ISSUE: Certificate of Appropriateness for alterations (signage)

APPLICANT: Frances Valentine (business)

LOCATION: Old and Historic Alexandria District
924 King Street

BAR#2023-00336
924 King Street

Figure 1: Existing South Patrick Street façade with proposed blade sign location and design

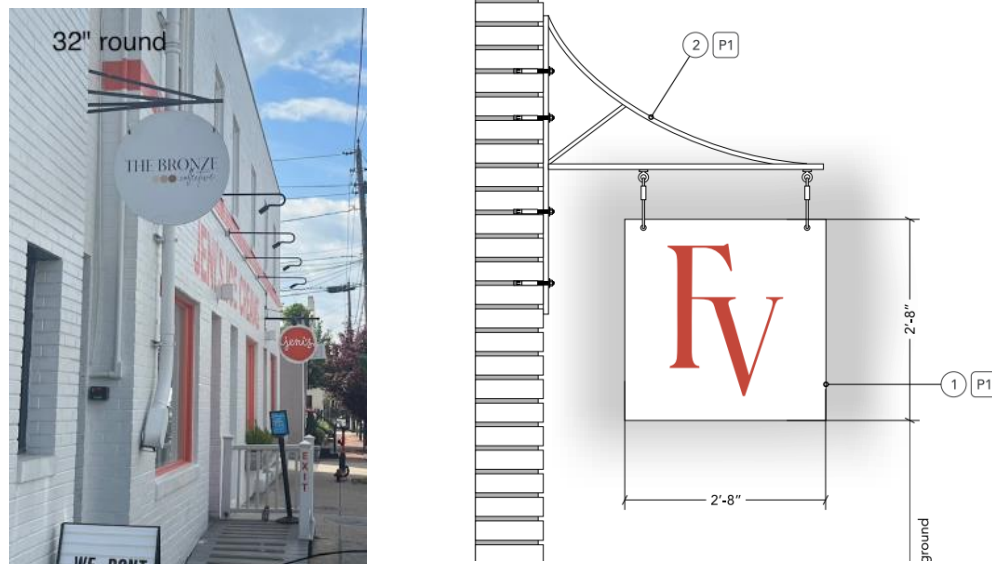
Staff finds that the proposed blade sign is appropriate and aligns well with the existing blade sign for Jeni’s Splendid Ice Creams along the shared façade. Staff also finds that the design of the proposed awning is appropriate for this mid-20th century building and does not detract from any historic architectural features; it will serve to orient pedestrians to the business. The striped design is compatible with the simple and unadorned masonry façade. Awnings for the King Street façade were previously approved by the Board in 2003 (Figure 4). The design of the proposed stud-mounted letter signs is also appropriate, and the size does not overwhelm the building. Bellacara, the business located on the other corner of King Street and South Patrick Street, has a similar configuration of one blade sign and two letter signs with one letter sign on each façade. Staff has no objection to the proposed blade sign or stud-mounted letter signs.

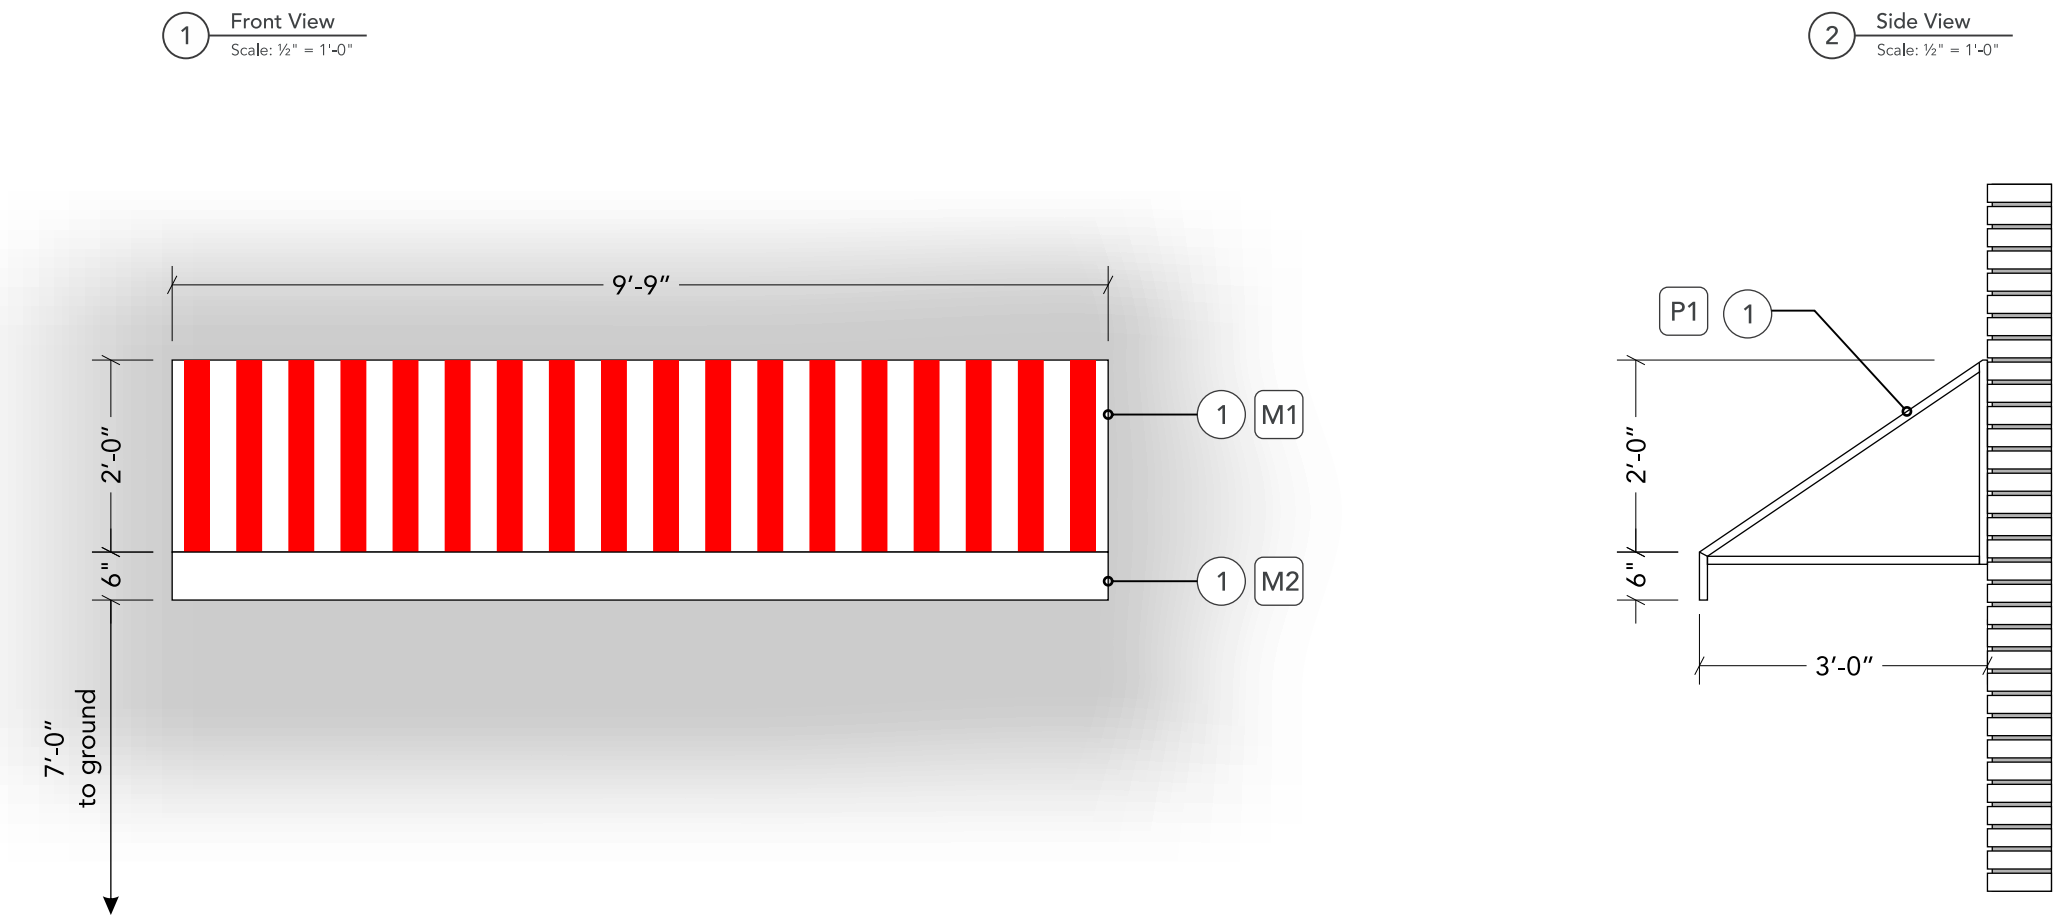
However, in the opinion of Staff, the second awning on the South Patrick Street façade is excessive as it would visually overwhelm the façade of the building that also includes Jeni's Splendid Ice Creams. The façade of Jeni's has one painted wall sign and one blade sign; Staff believes that adding an awning to only one business would appear incongruous with the existing shared façade, creating an image of two distinct buildings and detracting from the image of the streetscape.

1. The proposed awning on South Patrick Street is removed from the project scope.
2. Anchors for the signs and awning must be installed into the mortar joints to avoid damage to the masonry unit.
